# Dung Duc Tran et al. Assessing impacts of dike construction on the flood dynamics in the Mekong Delta

Responses to Reviewer#1 comments

Responses to Reviewer#2 comments

Figure 3: Time-series from simulation and actual flows observed in 2011 at representative stations

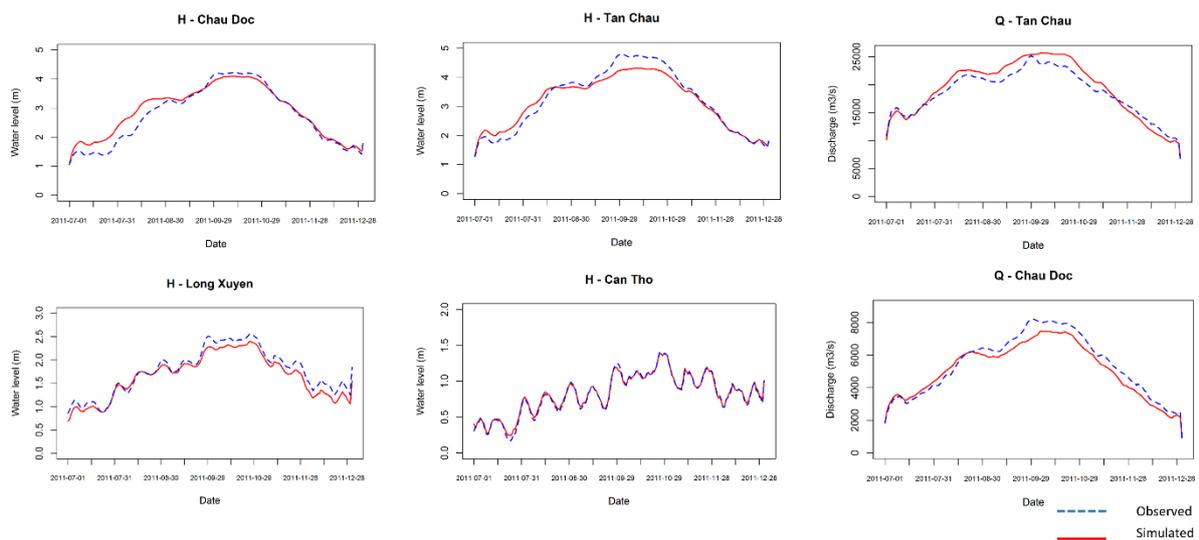
**14. Comment P14 Ln19:** I’m confused about the Q-Q plots in figure 3. What does each point represent? Are they daily simulated and observed streamflow? If yes, the authors should consider the time-series plot for the streamflow results.

**Response:** Each point in the Q-Q plot in Figure 3 represents the correlation between daily simulated and observed streamflow, based on Correlation Coefficient ( $R^2$ ) and Nash-Sutcliffe Efficiency (NSE). We agree with Reviewer#1 to present some time-series plots in the manuscript instead of the Q-Q plots. Another reason is that Table 1 already shows the NSE and  $R^2$ . All the Q-Q plots are presented only in the Appendix. We also add all time-series plots to the Appendix. Figure 3 is captioned as “Time-series from simulation and actual flows observed in 2011 at representative stations”.

Figure 4: Simulated and observed maximum water levels for the 2000, 2011 and 2013 flood years at 4 different stations along the Hau River.

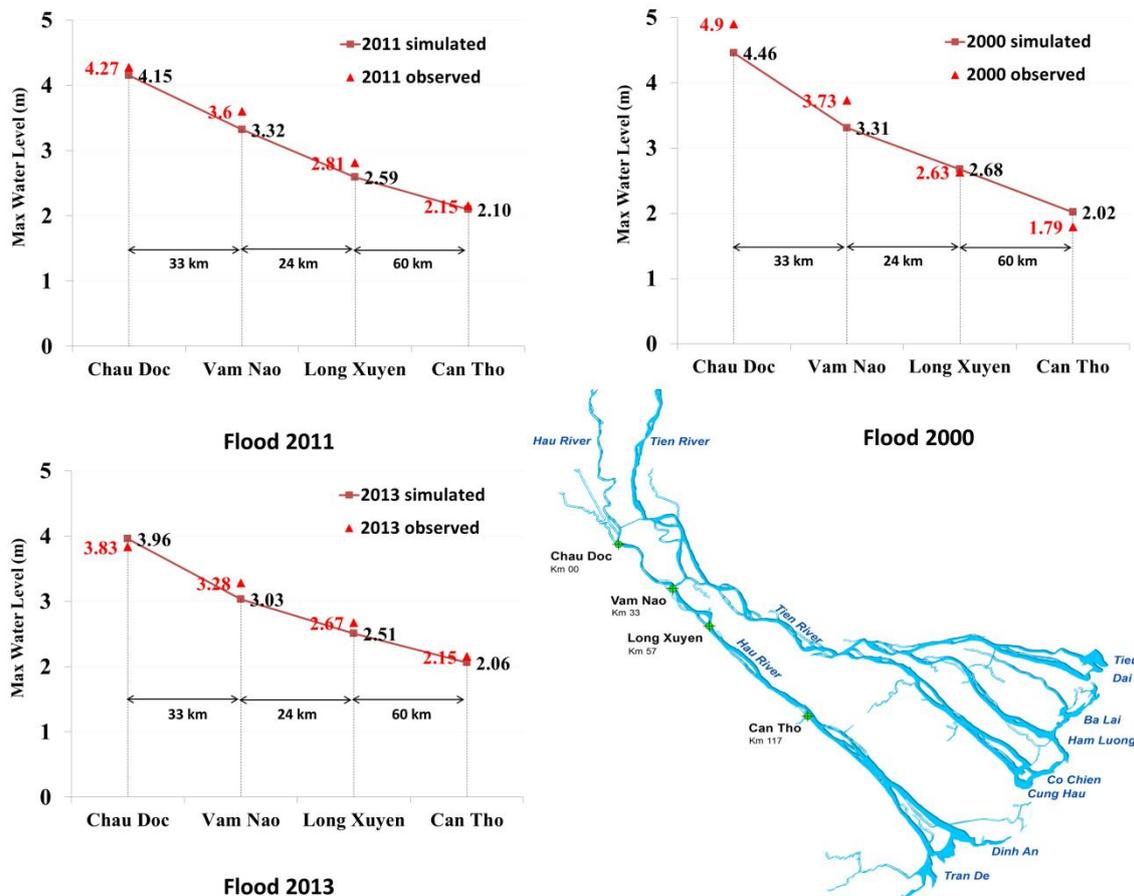
**15. Comment P15 Ln12-13:** The x-axis of figure 4 should be the distance instead of the sites. I expect the explanation of underestimated simulated streamflow to be right after the figures.

**Response:** In the submitted manuscript, we used the 4 sites instead the distance shown in the axis because these are important points measured along the Hau River. For example, Chau Doc

and Can Tho are two points we explore the difference in measured water levels between the floods of 2000 and 2011. In addition, the x-axis of Figure 4 also shows the distance of 4 sites. We added an explanation of underestimated simulated streamflow from Figure 4 (below) in the revised manuscript.

Added text right after the figure: “Figure 4 shows a good fit between the simulated and observed peak water levels for the floods in 2011 (calibration) and 2013 (validation). In the flood 2000, the fitness is low due to the significant changes in physical topography such as river network and branches and river cross-sections between the model setup of 2011 and the measured data in 2000.”

Figure A2: The left figure describes the 1D-quasi2D modelled river network of the VMD and the right figure show a representative typical floodplain compartment. The approach is from Dung et al. (2011).

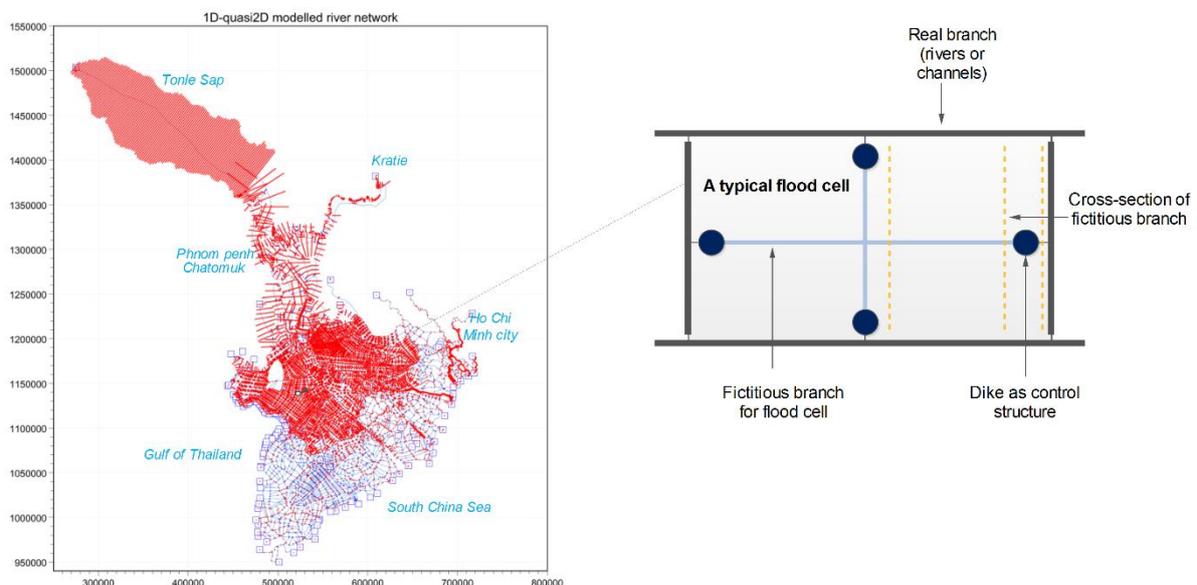
**2. Comment Description of model set-up:** A crucial aspect is the flooding in cross-sectional direction in this 1D model. A quasi-2D approach is applied for the flood plains. This is explained very briefly and should be explained in detail, because it has a large impact on the model results.

**Response:** We agree with Reviewer#2 to describe more about the methodology of quasi-2D approach in the revised manuscript. We added and revised text to explain more about the methodology and model technicalities. In addition, a figure (Figure A2) is added to the Appendix to illustrate the quasi-2D modelling method.

*Figure 3: Time series from simulation and actual flows observed in 2011 at representative stations.*

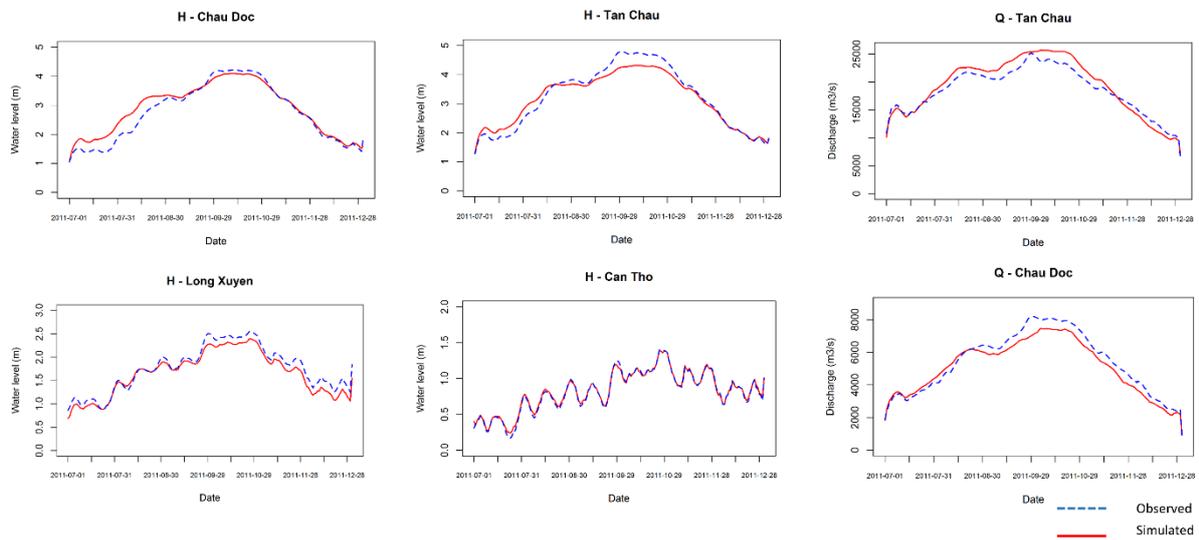
**4. Comment Presentation of model results:** One expects figures with time series of water levels and discharges that contain both numerical results and measurements. However, such

plots are missing. Therefore, a reader does not have any insight whether the time behavior of the floods is simulated accurately. Instead, correlation numbers and maximum high water are presented in the figures. However, this is of secondary importance. The authors are strongly advised to add several time history figures with computed and measured results.

**Response:** We added time-series of computed and measured water and discharges for several representative stations (Figure 3) in the revised manuscript. Besides, the Q-Q plots and time-series plots of all stations are presented in the Appendix.
